July 2018  
FL764A  
NHTSA #18V-194

## Subject: FCCC Motorhome Valve Stem Stabilizers

**Models Affected: Specific Freightliner Custom Chassis X-Line motorhome chassis manufactured November 2, 2016, through January 10, 2018 and equipped with a single drive axle.**

Fig. 1, Valve Stem with New Stabilizer

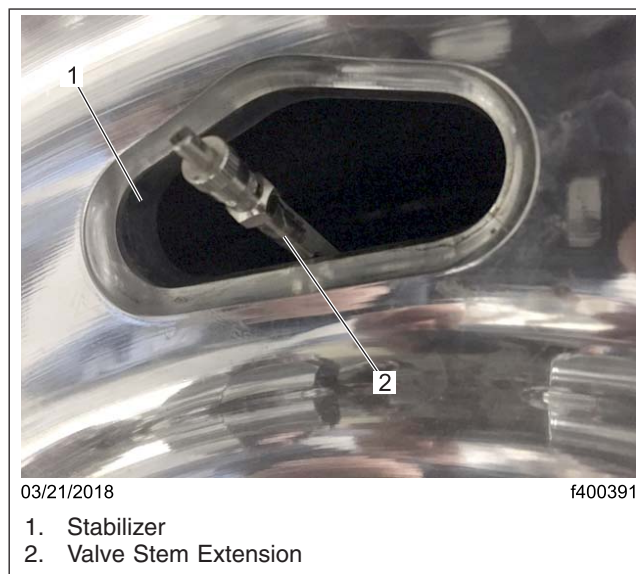
Certain chassis may have been built with an incorrect valve stem stabilizer. It may become dislodged from the wheel, allowing the valve stem extension of the inner wheel to contact the outer wheel, potentially damaging the valve stem and resulting in a loss of air pressure in the inner tire. A loss of air pressure in the inner tire on a motorhome with a single drive axle may overload the outer tire and increase the risk of a crash.

The inner wheel valve stem stabilizers will be replaced with the correct valve stem stabilizer and wheels will be replaced if needed.

5. Install a new valve stem extension stabilizer. Insert the valve stem through the hole in the stabilizer, then press the stabilizer into place.
6. Clean a spot on the base label (Form WAR259). Write the recall number, FL764, on a completion sticker (Form WAR260), and attach it to the base label to indicate this recall has been completed.
